# North Red Deer Regional Wastewater Services Commission

# Lacombe Lift Station Pump Update

Technical Memorandum #18 – Pump Operations R2

With response to the problems in Lacombe Pumping Station and Blackfalds Pumping Station (XFP 306M-CB2 PE2800/4.60 and XFP306M-CB2 PE3350/4), Sulzer has reviewed the design and installation of the submersible pump dry pit configuration.

## Investigation at site

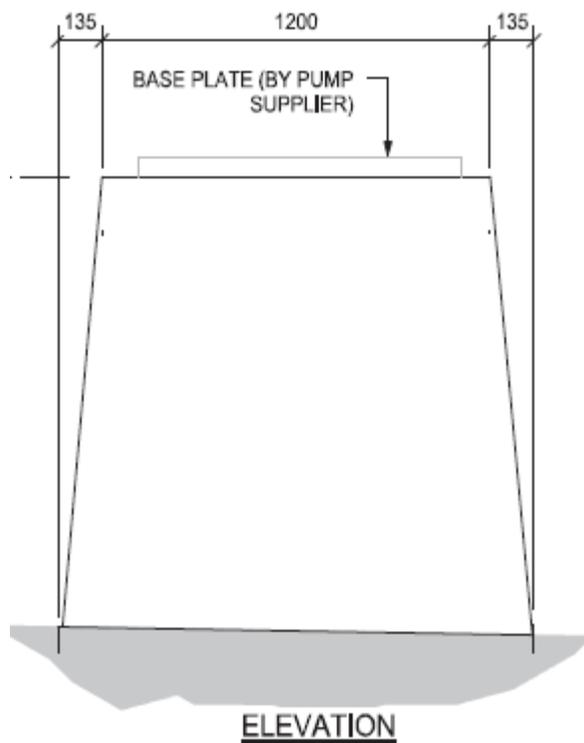
During a site visit on November 23, Sulzer reviewed the layout of the station, measured the dimensions of the bases, and measured the vibration using a Wilcoxon PVM 100 portable vibration meter.

- 1. Dimension of bases:** We found the bases were not built as per Stantec drawing.

**2. Poor finished Concrete bases:** The bases show many cracks and holes.

1. The most suitable and logical way to proceed in ensuring a mitigation of the reported vibration is to ensure a strong fixing of the individual components such as volute, steel frame and plinth.

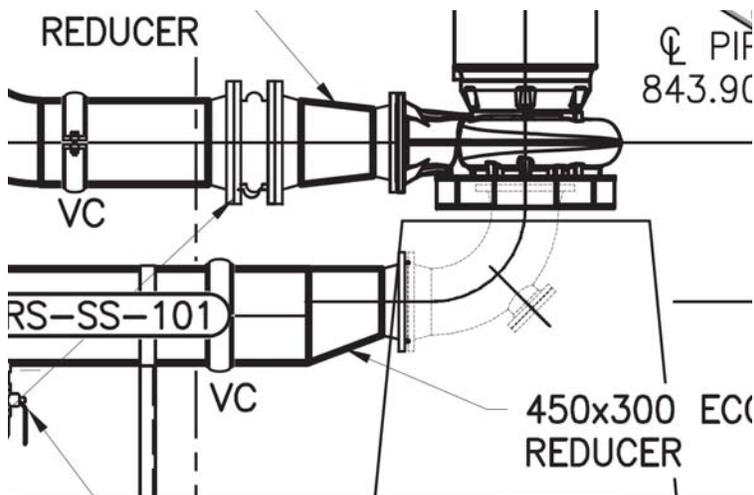
Actual measurement on pump #102, at 1116m<sup>3</sup>/h, the Velocity RMS value is 7.112mm/s (point A), 4.318mm/s (point B) and 4.826mm/s (point C).

Lacombe Data Collection				
60Hz - Pump 102 - 310 L/s -@ 530 KPA				
Point on Unit	G	IPS	MM/S	Mil
A	1.5	0.28	7.112	3
B	1.99	0.17	4.318	2
C	3.05	0.19	4.826	1.9
D	1.55	0.15	3.81	2.5
E	0.52	0.32	8.128	3.4
F	0.26	0.07	1.778	0.4

### CFD Swirl Angle and Velocity

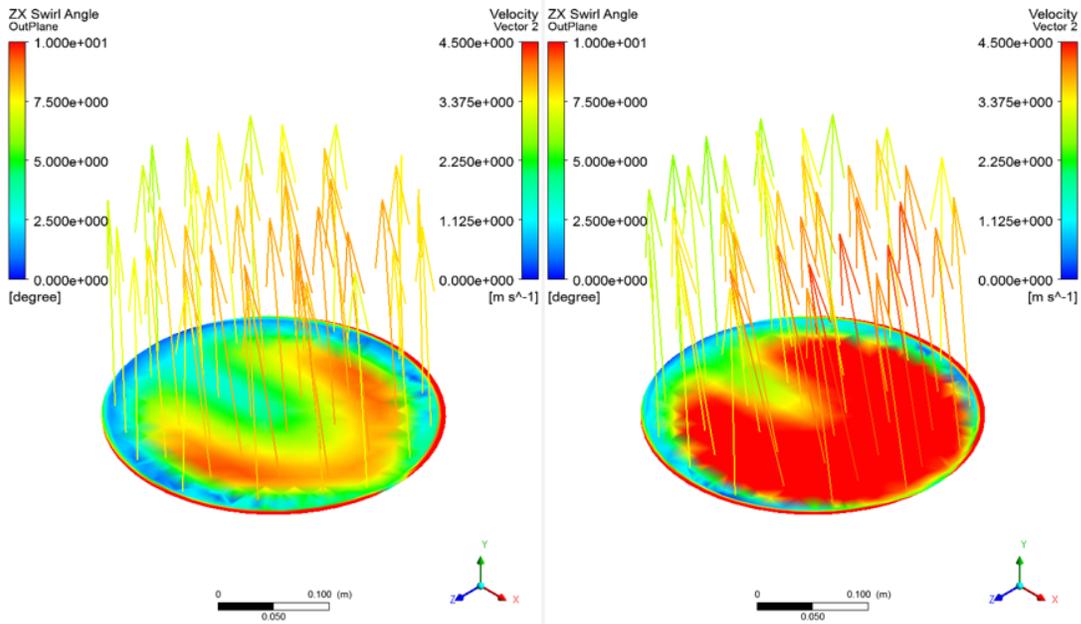
- 4. Suction pipe reducer and suction elbow:** The suction pipe reducer (450 x 300mm) right before the 90 degree suction elbow (300 x 300mm) leads to a high flow speed and flow separation creating non-uniform inflow into the impeller.

As a CFD study in another similar installation, a short radial elbow can create uneven flow (in RED).

■ Left : max 10° (red | swirl angle)

Right: max 10° (red)

This for part load recirculation vortices at lower flow (very left of BEP). Also, to avoid too high swirl angle ( $> 8^\circ$  at 80% at suction plane) and an uneven velocity distribution ( $> \pm 10\%$  of  $v_{\text{mean}}$  at 80% at suction plane) at higher flows  $> 4 \dots 5$  m/s.

6. Solution B: Move the existing reducer (450 x 300mm) away from the suction elbow (keep minimum 3 times of the pipe diameter from the suction elbow) to minimize the influence created by high flow speed and flow separation. Solution B will require less site modification. However, Solution A will improve the performance more significant than Solution B.

# Case No. 1 – Existing, Two Pumps Running

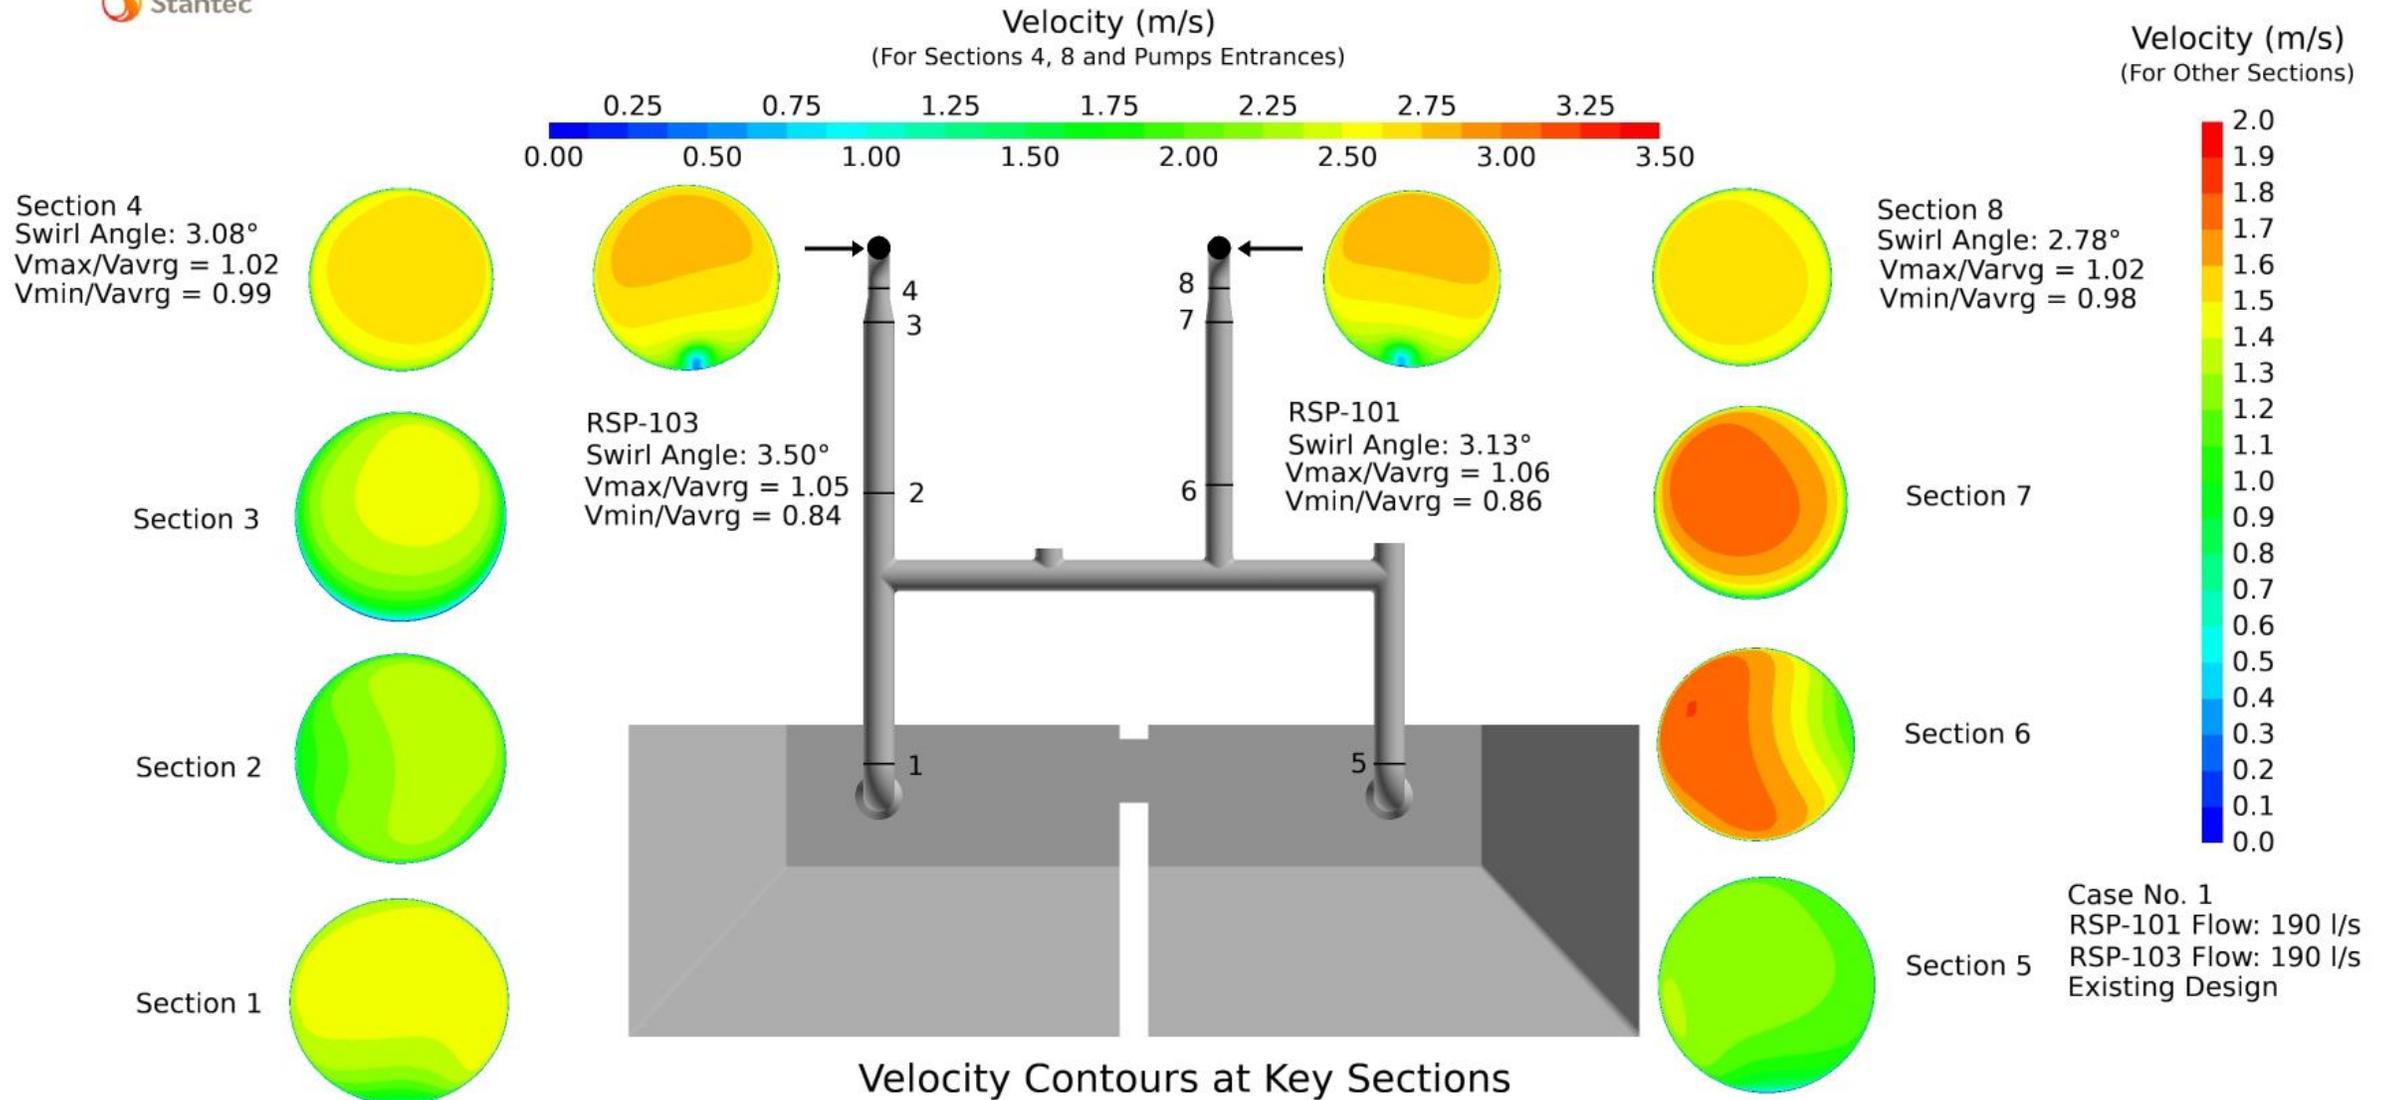
- Predict flow patterns and hydraulic conditions at the suction piping and pump entrances.
- Develop/evaluate possible modifications to minimize pump vibration.

# Case No. 2 – Existing, RSP-103 Running

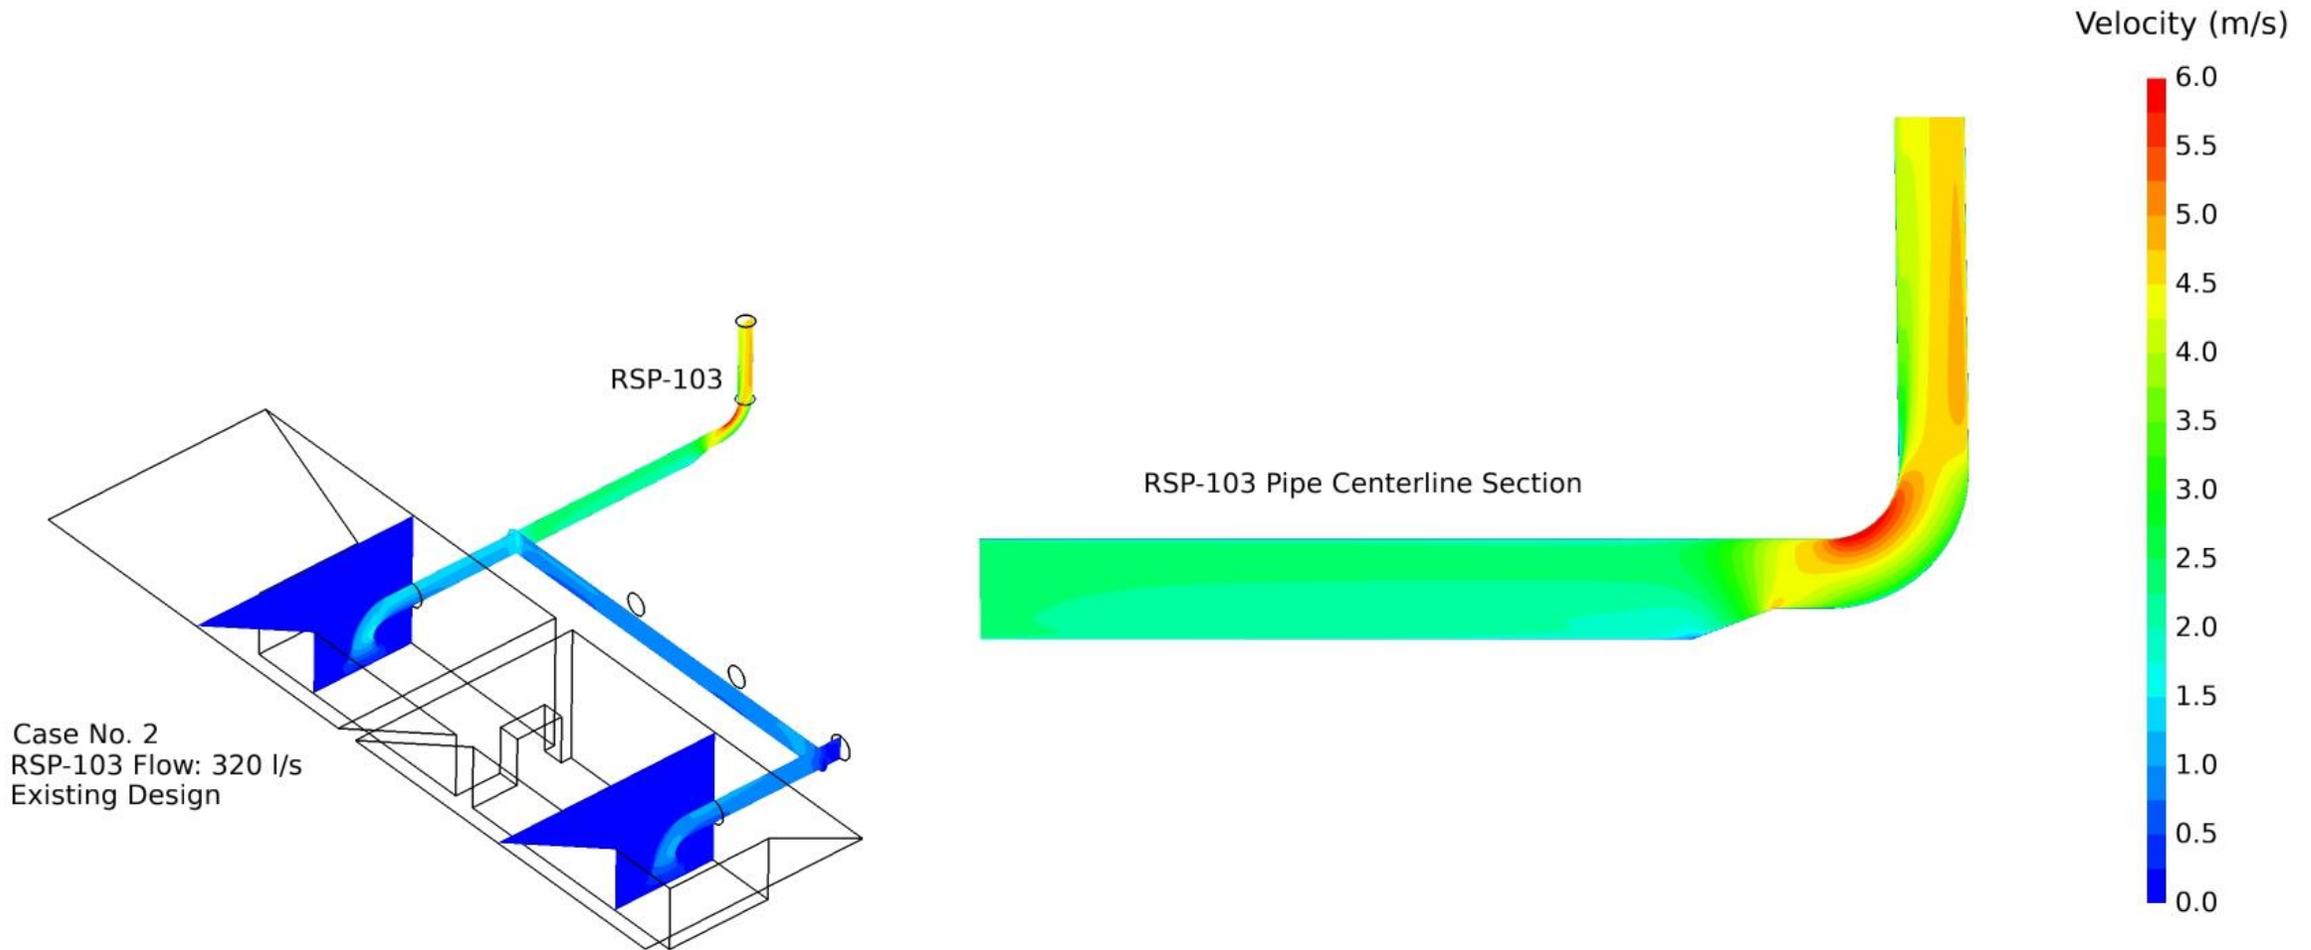
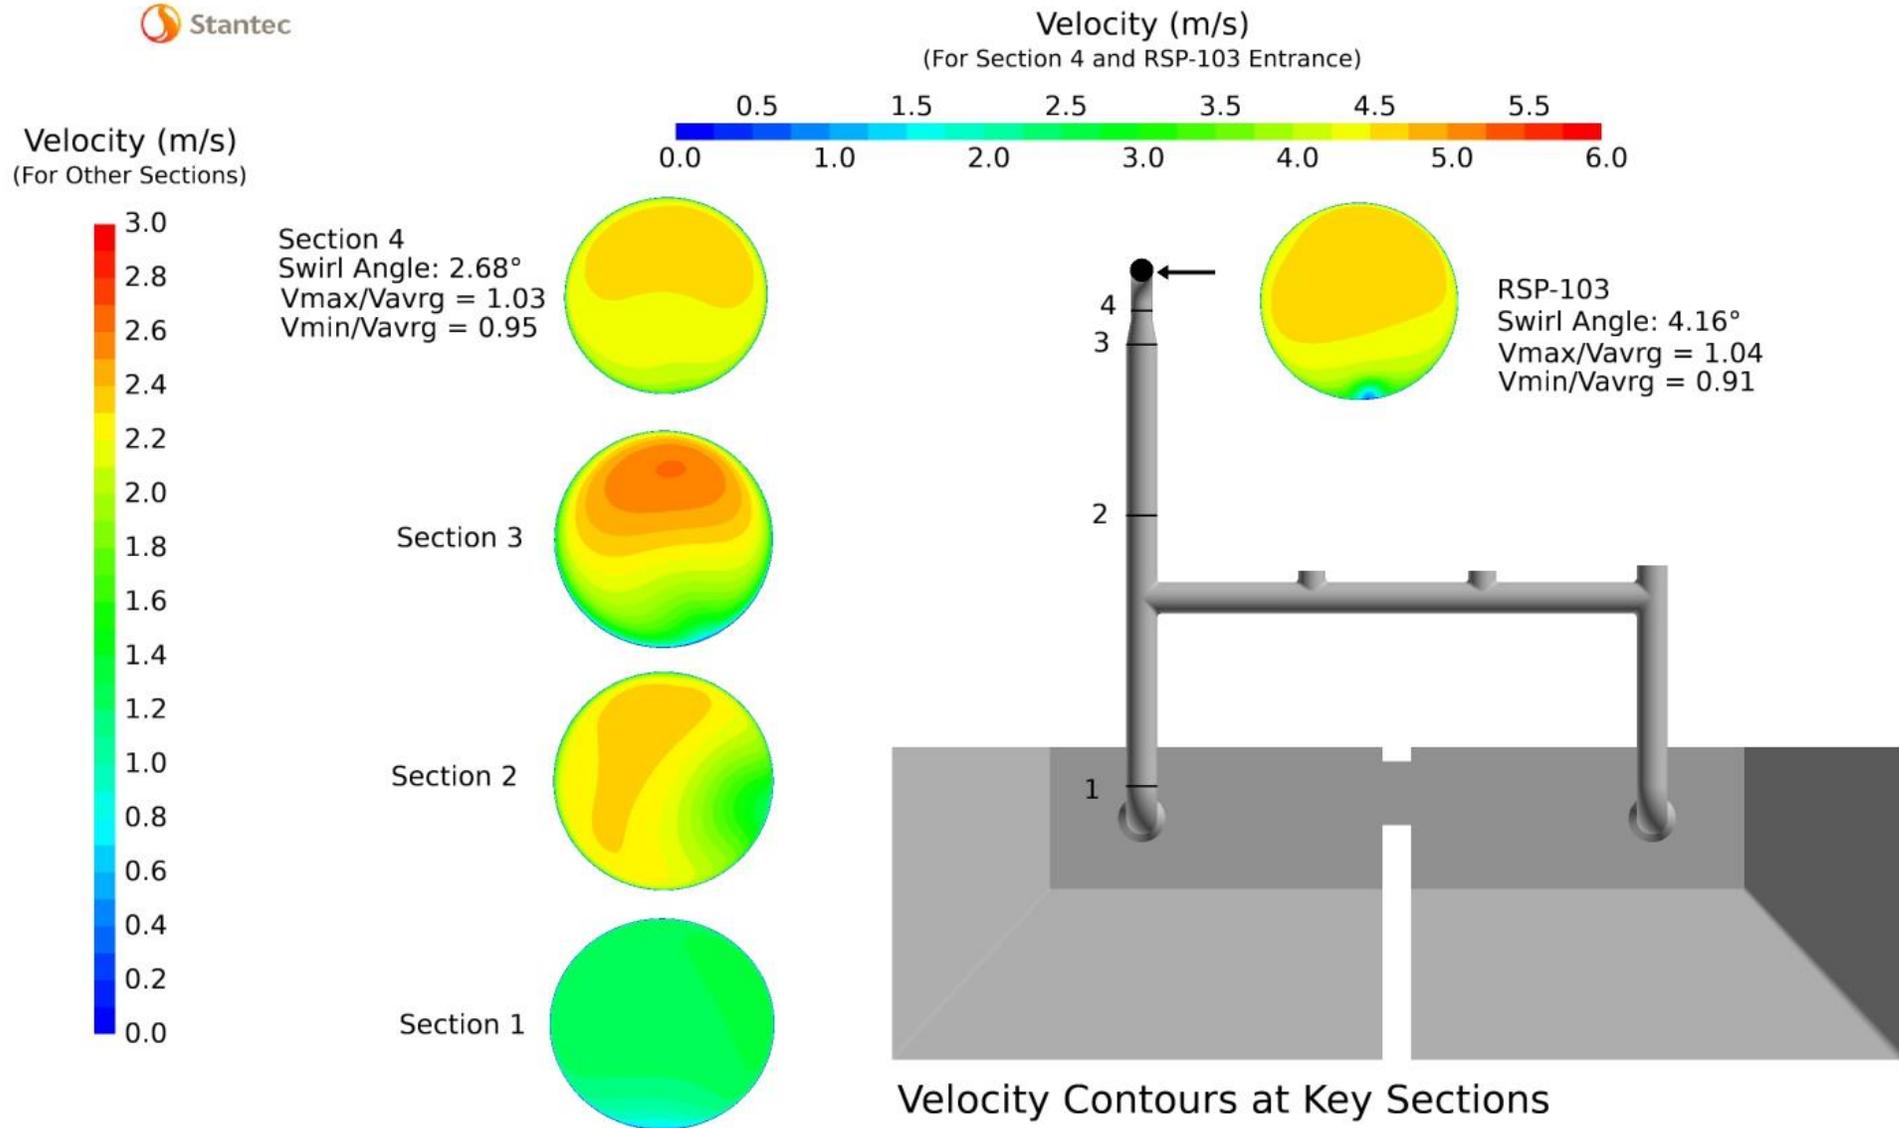
Case No. 2  
RSP-103 Flow: 320 l/s  
Existing Design
